MEMORANDUM

CITY & BOROUGH OF JUNEAU

FILE NO.: VAR2012 0007

PROPOSAL: A Variance to the 50-foot no development setback and 25-foot no disturbance zone from Auke Lake for Auke Lake Wayside Recreational Improvements.

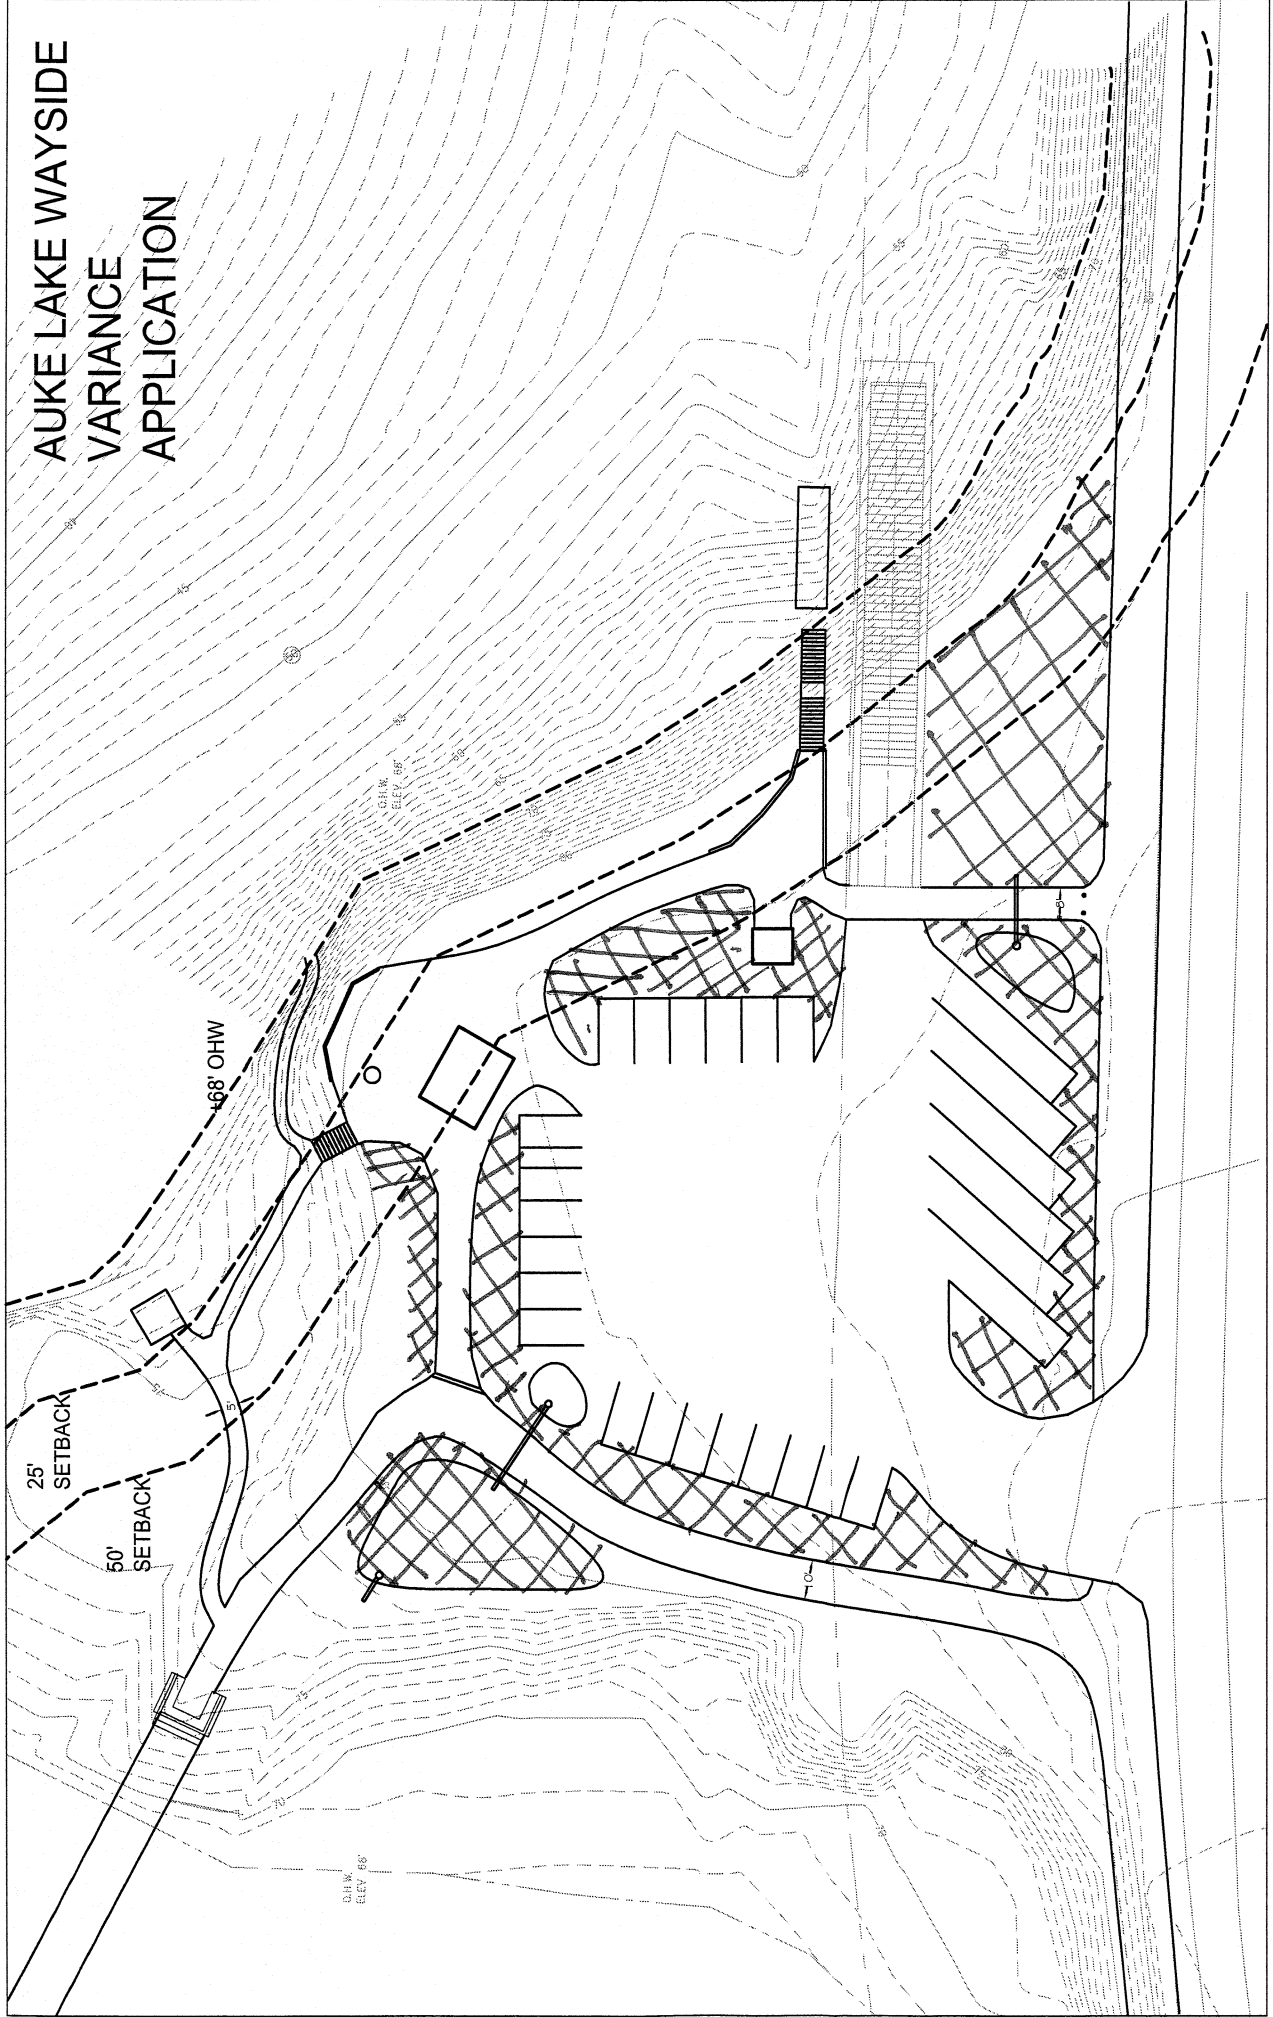
The original master plan has been revised to move the gravel trail between the viewing deck and the stairs to the picnic shelter outside of 25' lake setback zone. Staff still recommends placing a fence at the top of the undercut slope just beyond the picnic shelter to prevent further erosion caused by people sliding, jumping and climbing the slope. At the base of this slope, there is a deep water hole where boaters nose their boats into shore to access the wayside. They continue to do this because the shoreline is softer material than the concrete boat launch ramp and many of the boats are fiberglass. In the attached photos it is clear that many people climb up, slide down or jump down the steep slope to access the parking area. The slope is slightly undercut and eroding from this use. There is a narrow trail leading around the slope and up to the parking area. The plan proposes putting a few inches of gravel on this narrow trail and building stairs to delineate a stable pathway for access to this deep water hole. The fence needs to be close to the edge of the slope so that it presents a vertical impediment to people trying to move up and down the eroded area. If the fence is kept outside of the 25' setback zone, there will be a flat area of approximately 15' between the fence and the slope. This will be inviting to users for additional gathering space and access to move up and down the slope.

We have seen the boat launch ramp in use for over a year now. The boat launch ramp provides a stable concrete plank access for boats and users to access the water. However, people still walk down the steep, rocky slope immediately adjacent to the boat launch ramp to access the water. They have trampled the vegetation and this area will begin to erode if it is not stabilized. The park users have very defined patterns of use at this site and will continue this pattern if able to do so relatively easily. The plan proposes building stairs along the slope by the boat launch ramp and placing a fence close to the slope by the deep water hole to try and guide and direct water access routes.

*Revegetation Areas*

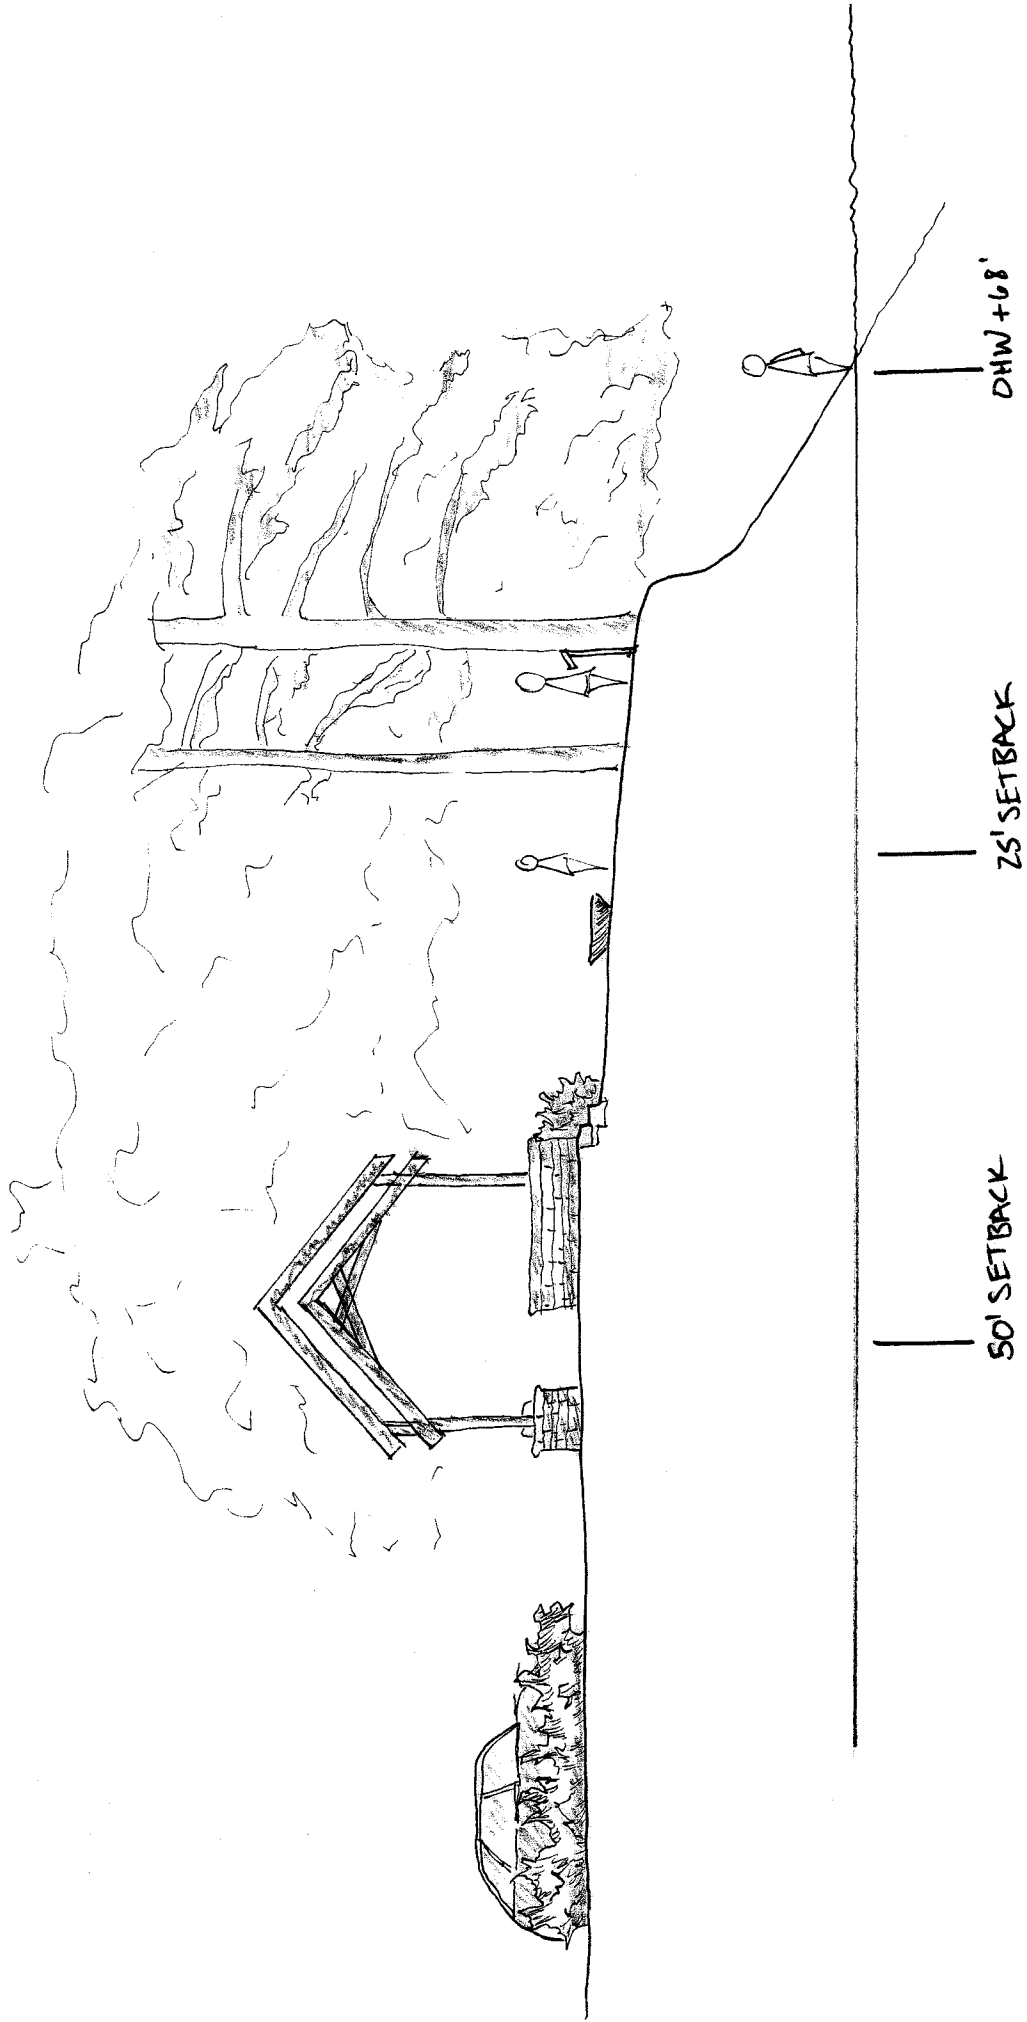
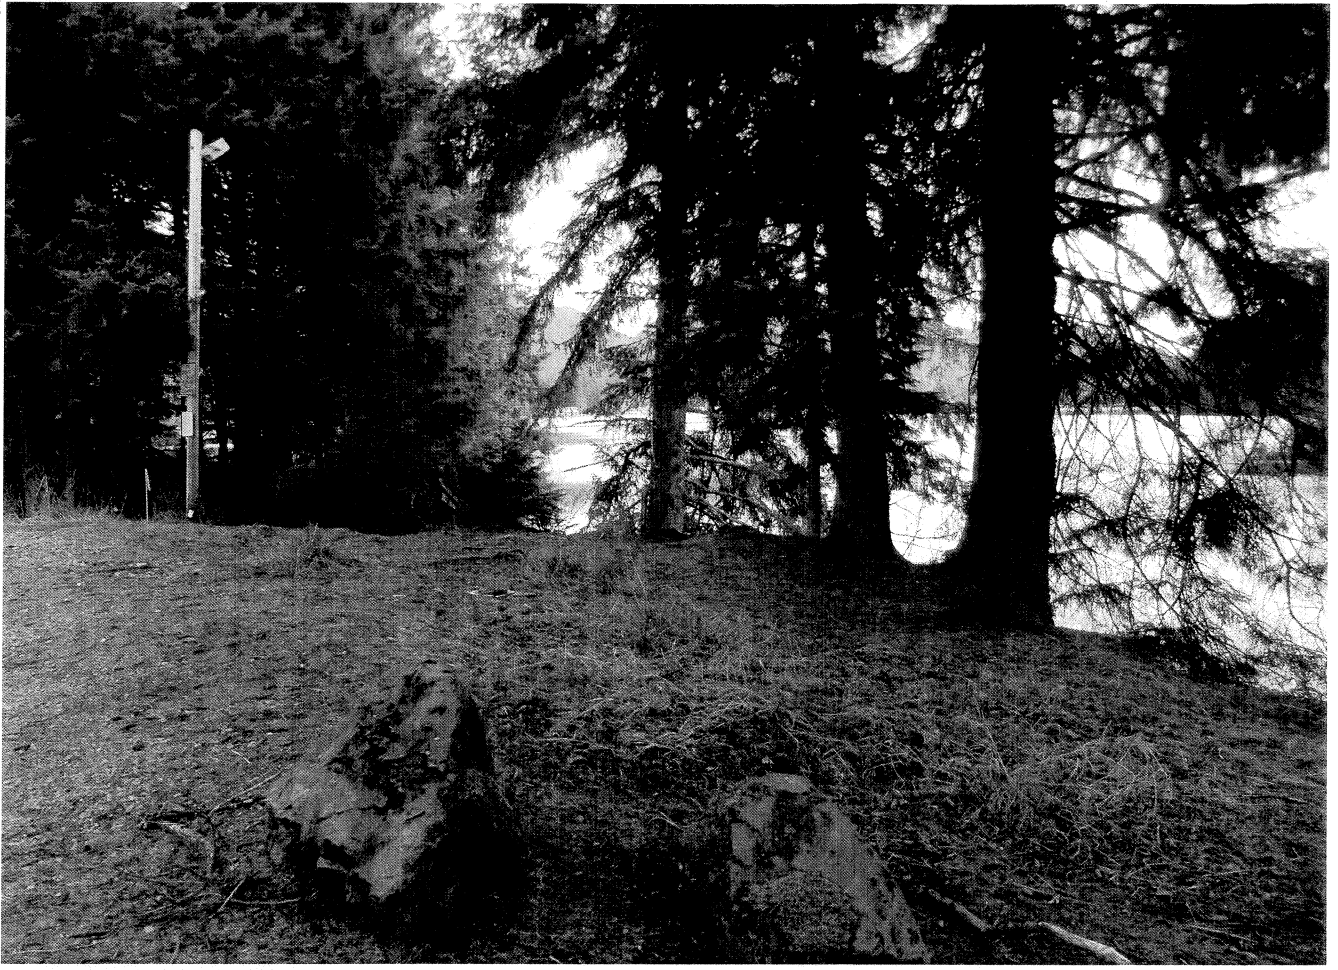
The WRB supports the project because of the reduced erosion potential and because of the extensive restoration efforts both within and outside of the 25-foot no-disturbance zone. The WRB supports the viewing deck within the 25-foot no-disturbance zone because the intent is to reduce erosion. All other project elements should be kept outside of the 25-foot no-disturbance zone if possible, especially the fire pit/picnic shelter and associated grading.

Mr. Stekoll and Mr. Schaaf agreed to provide a revised drawing by Monday which shows the 25-foot no-disturbance zone and a modified design which pulls the fire pit/picnic shelter outside of the zone. The revised drawing will also show the areas that will be revegetated, because board members believe this provides mitigation for impacts within the 25-foot and 50-foot zones and therefore should be specifically noted on the plans.
